### APPEAL SUMMARY

**Appeal ID:** 19041

**Project Address:** 631 SE Taylor St

**Building/Business Name:** The Rose Apartments

LIFE SAFETY PLANS -  
APPEAL

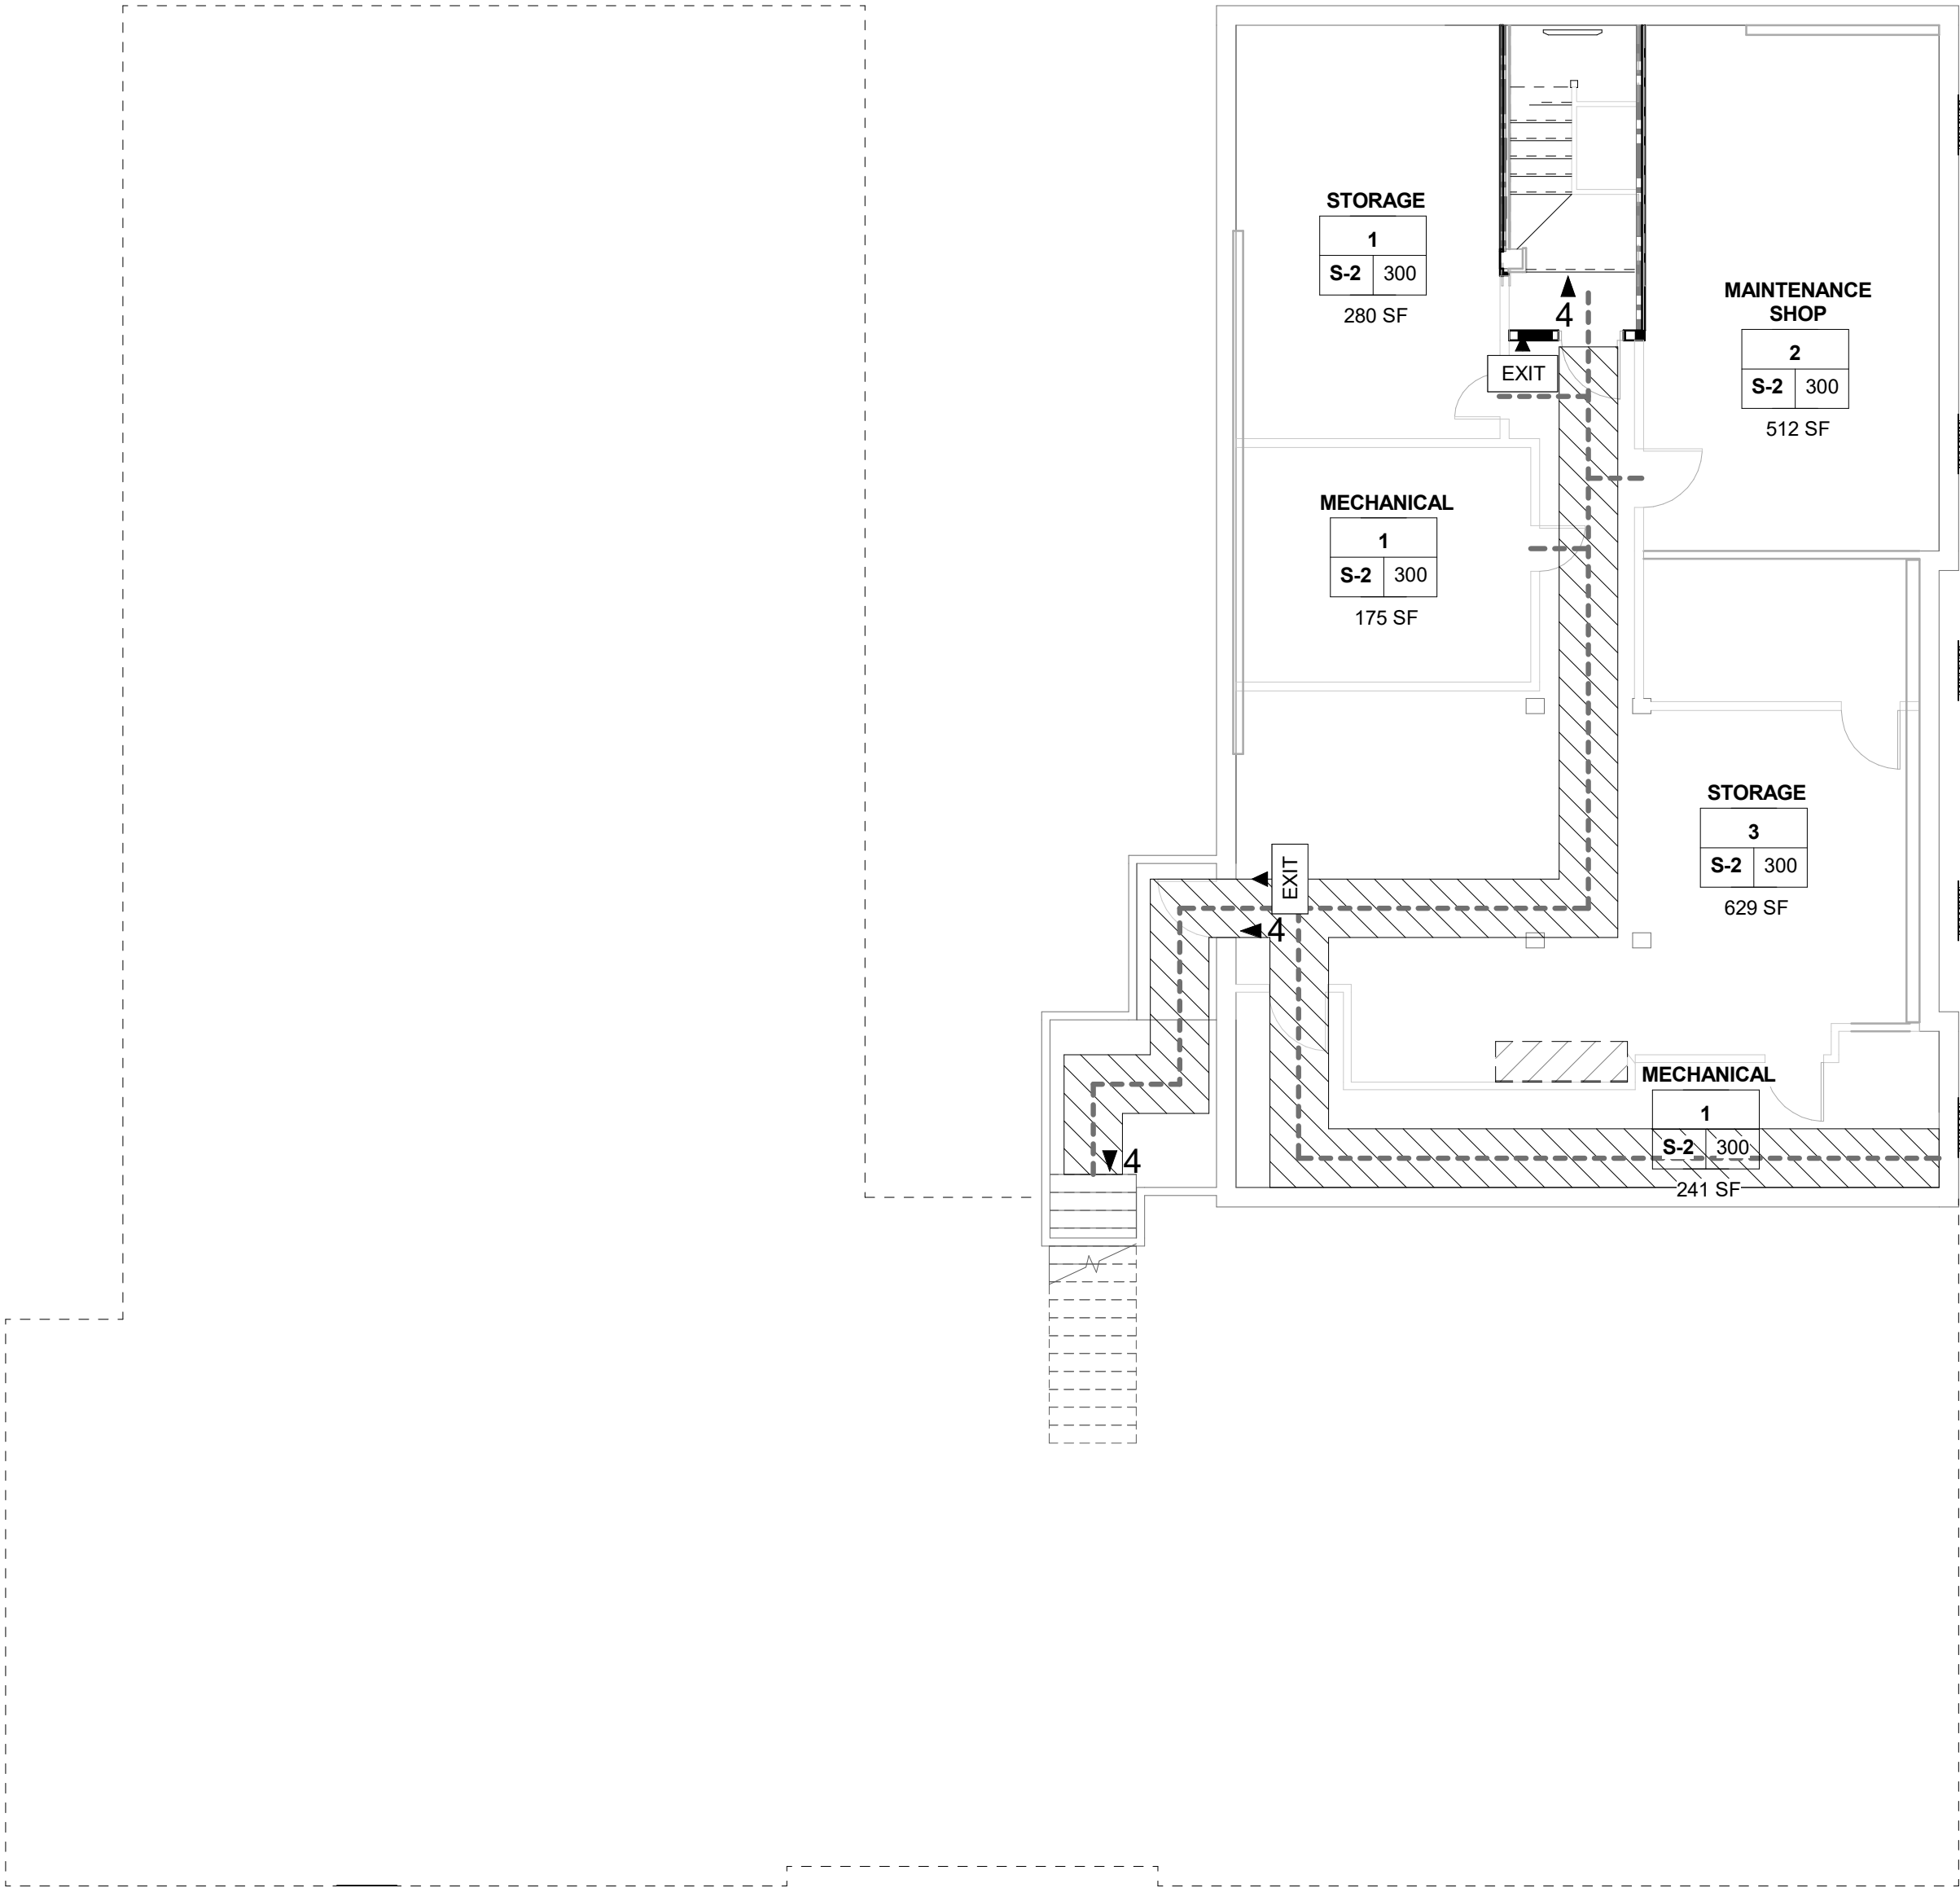
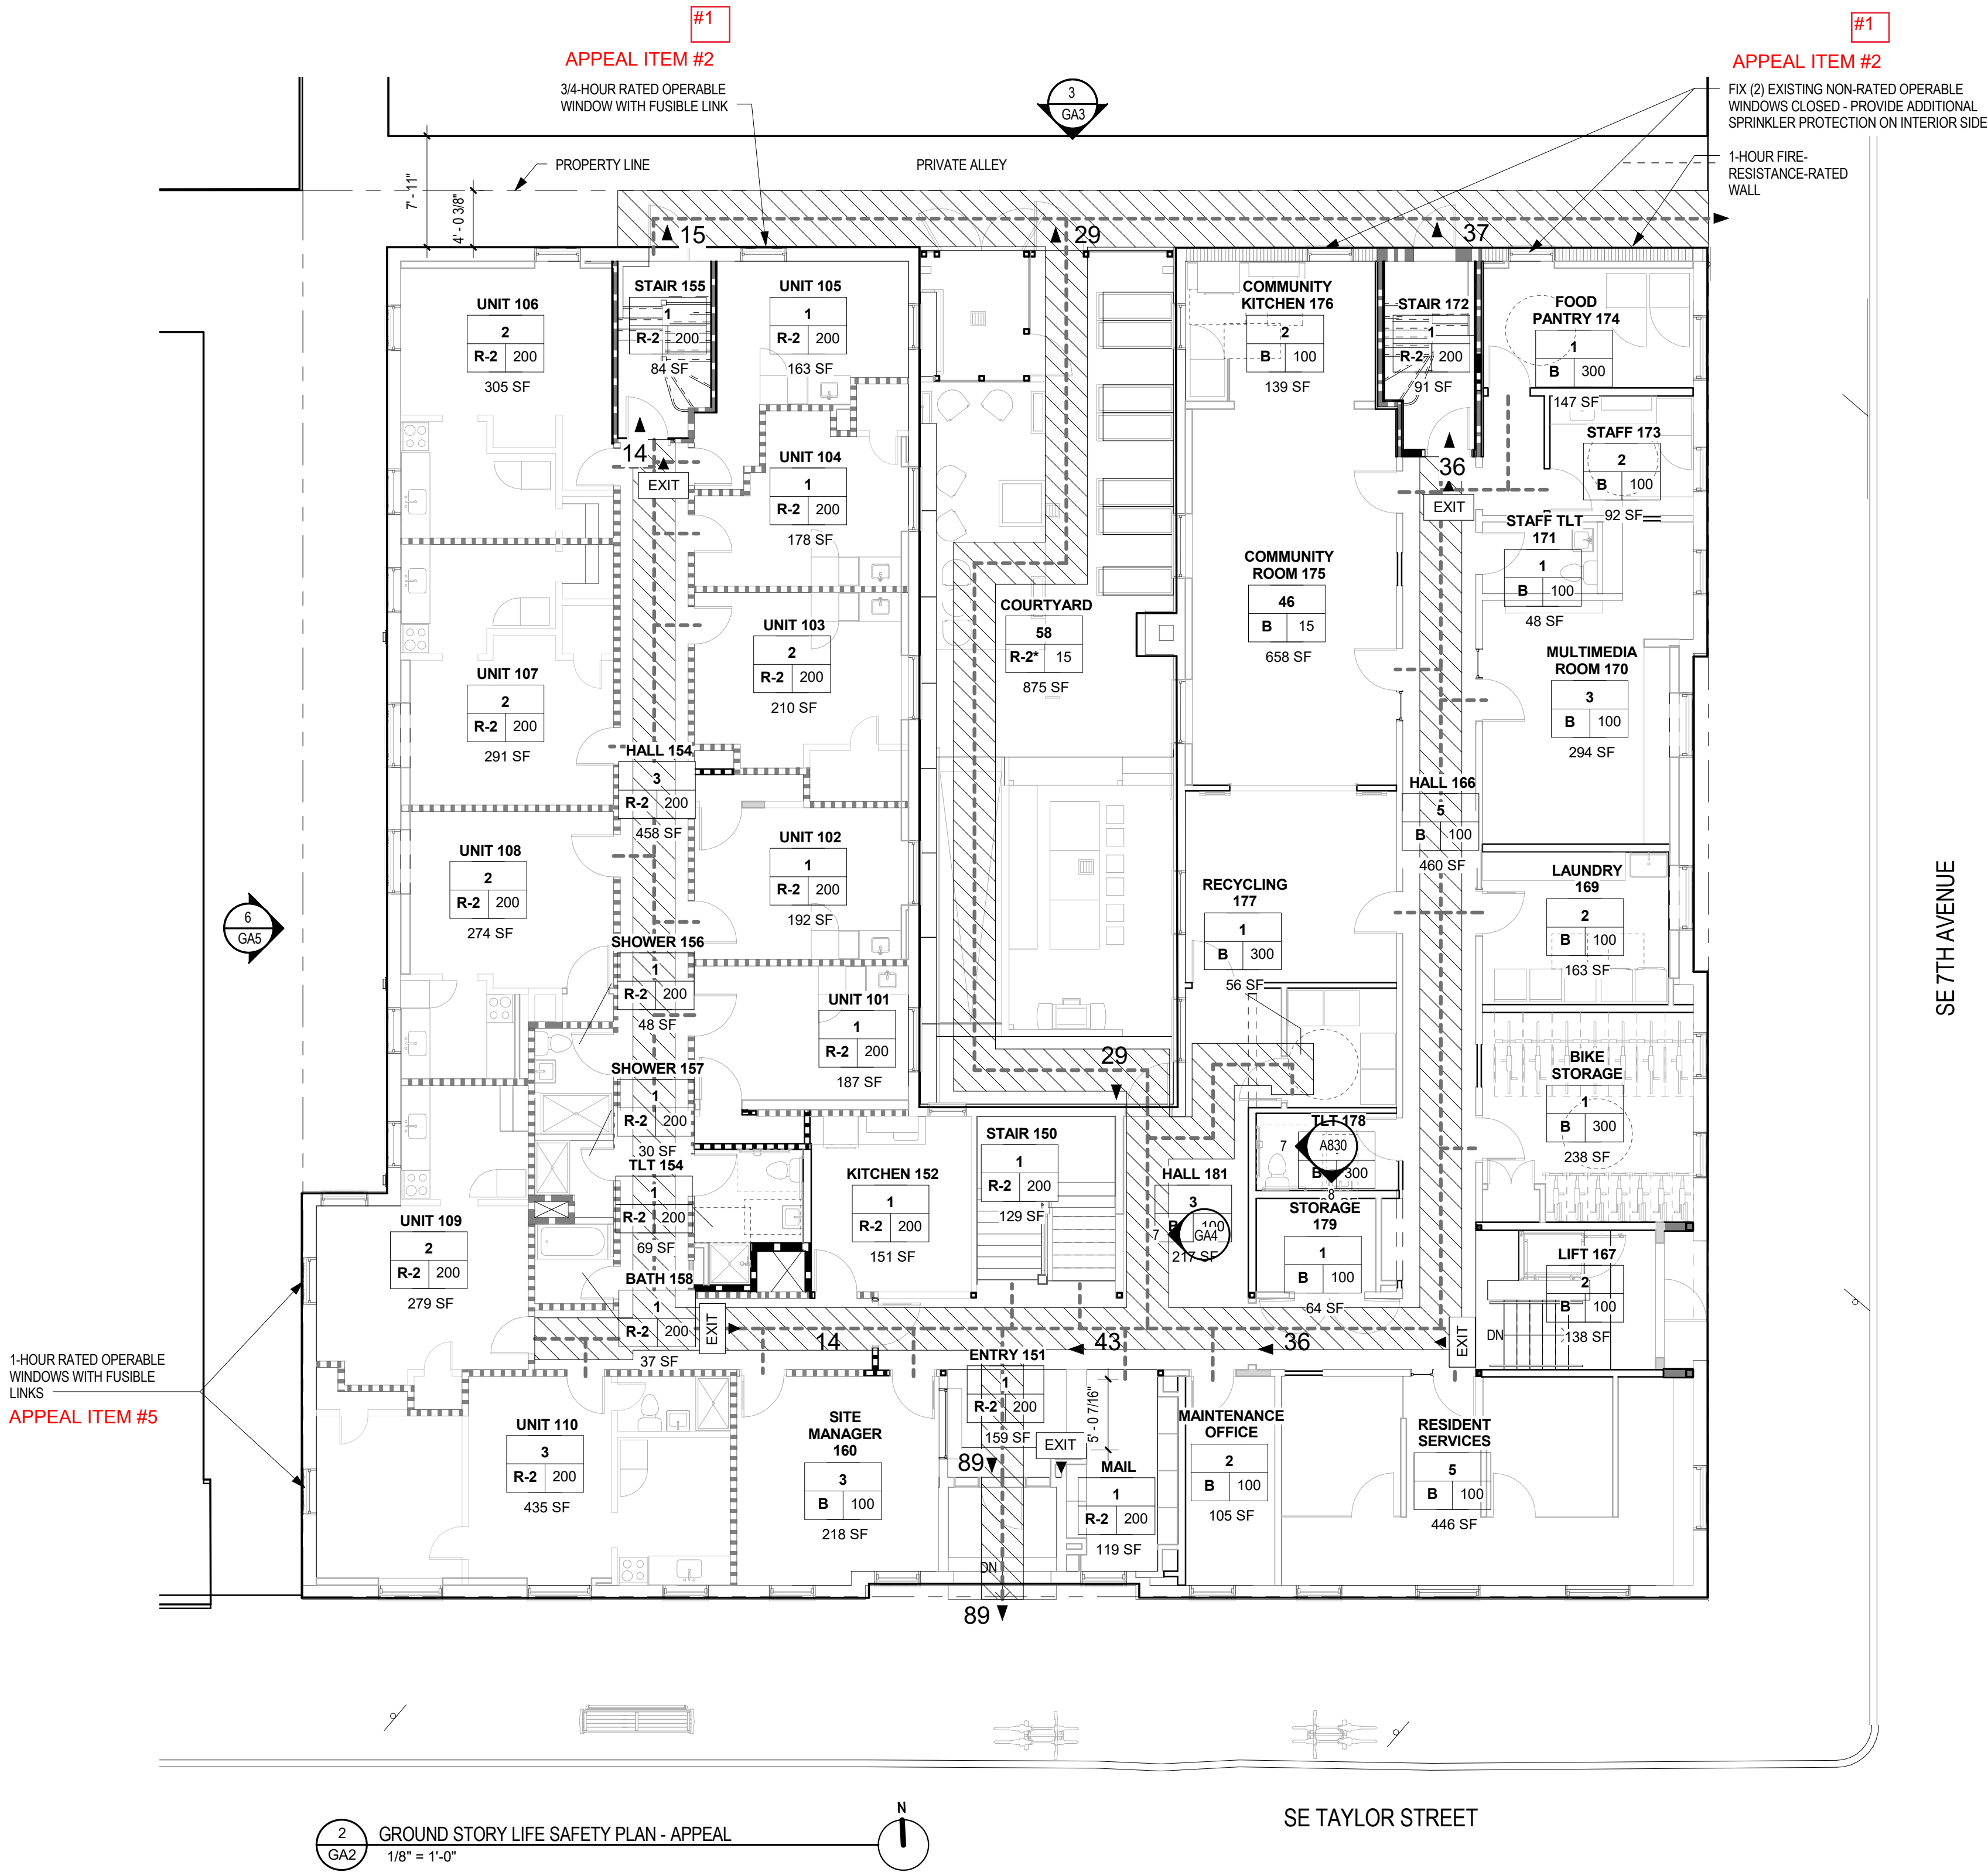
ORIGINAL APPEAL TEXT: The existing northeast stair exits to a private alley that leads to the public way. As part of the remodeling of the ground story administrative/common use spaces and exterior courtyard, 33 additional occupants will be egressing through the alley. The alley is 8 feet wide overall; 4 feet of this is on this project site. The north wall of the building is constructed of two wyths (+/-8") of brick and achieves the required 1-hour fire-resistance-rated construction per Table 721.1(2). The northeast exit stair door will be replaced with a 90-minute door as part of repairing that stair's required two-hour enclosure. The two existing ground story non-rated operable windows adjacent to the egress court (approved by Appeal #6358) will be fixed in place with additional sprinkler protection on the interior side. See Sheet GA2.

The existing north stairs exit to a private alley that leads to the public way. The alley is not a public way; it is on private property, as shown on Sheet GA2. It is approximately 8' wide, as shown on Sheet GA2. The property line runs down the middle of the alley. 4'-0" of the alley is on this project's site with the remaining 4' on the adjacent building's site, as shown on Sheet GA2.

There is one existing ground story non-rated operable window along the western portion of the egress court (Unit 105). This window was approved by Appeal #6358. This window will be replaced with a UL listed ¾-hour fire-rated operable window with a fusible link that closes the window in the event of a fire. There are two existing ground story non-rated operable windows along the eastern portion of the egress court (Kitchen 124 and Food Pantry 123). These windows were approved by Appeal #6358. These windows will remain and be fixed in place, with additional sprinkler protection provided on the interior side. See Sheets GA2 and GA3.

**1. Type 13 water curtain sprinkler protection at non-fire rated openings in exterior walls of egress court less than 10' in width: Granted provided windows are non-operable and sprinklers are spaced not more than 6 feet apart and placed a minimum of 6 inches and a maximum of 12 inches from the opening(s) and a maximum of 12 inches below the ceiling. Sprinklers are to be installed on the occupied side of the openings. A separate permit from the Fire Marshal's Office is required.**
